[EXT]RE: Dana Reserve Draft Environmental Impact Report - comments

Subject: Dana Reserve Draft Environmental Impact Report - Notice of Availability

WHAT: A Draft Environmental Impact Report (DEIR) for the *Dana Reserve Specific Plan (PLN-1118, SUB2020-00047, LRP2020-00007, ED21-094)* is complete and available for public review and comment. The document addresses the environmental impacts that may be associated with activities related to the adoption of the Dana Reserve Specific Plan (DRSP), including adoption of the Specific Plan, Conditional Use Permit for Oak Tree Removal and Grading/Impervious Surfaces, Vesting Tentative Tract Map (VTTM) 3159, Development Agreement, annexation into the Nipomo Community Services District's (NCS D) service area for provision of water and wastewater services, and a County-initiated General Plan Amendment to change the land use categories within the Specific Plan Area and reflect the proposed incorporation of the Specific Plan Area into the Nipomo Urban Reserve Line (URL). The *Dana Reserve Specific Plan* is a primarily residential project with a majority of the Specific Plan Area designated for residential uses, which would accommodate up to 1,28

Please see below Dana Reserve's plan and my alternative plan in comparison.

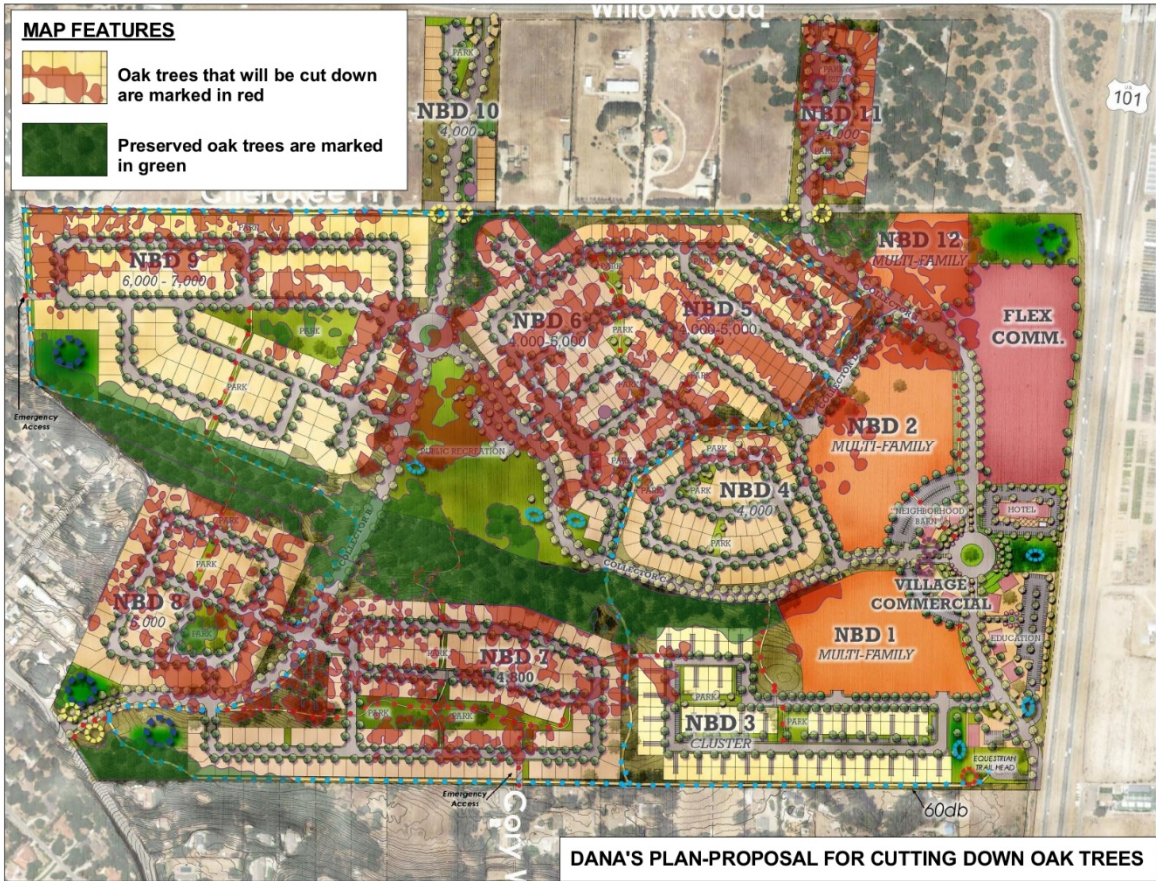
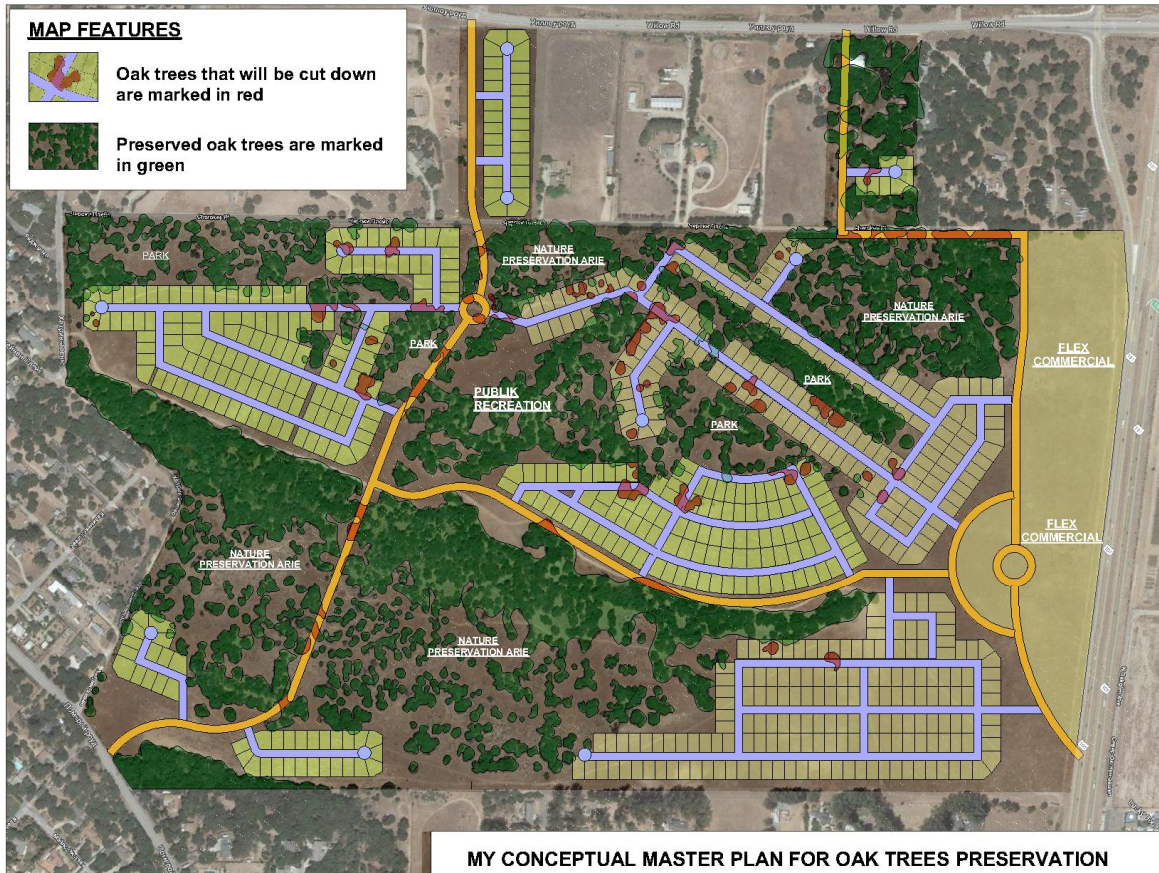
Once again I propose to reduce the appetites of Dana Reserve and force them to reduce the amount of development and only build where there are no oak trees (see my alternative site plan below, which I submitted first in July 2021).

Everyone will benefit from such a decision, the nature of California, the County, the population of Nipomo, and the tens of millions of people who drive along Freeway 101.
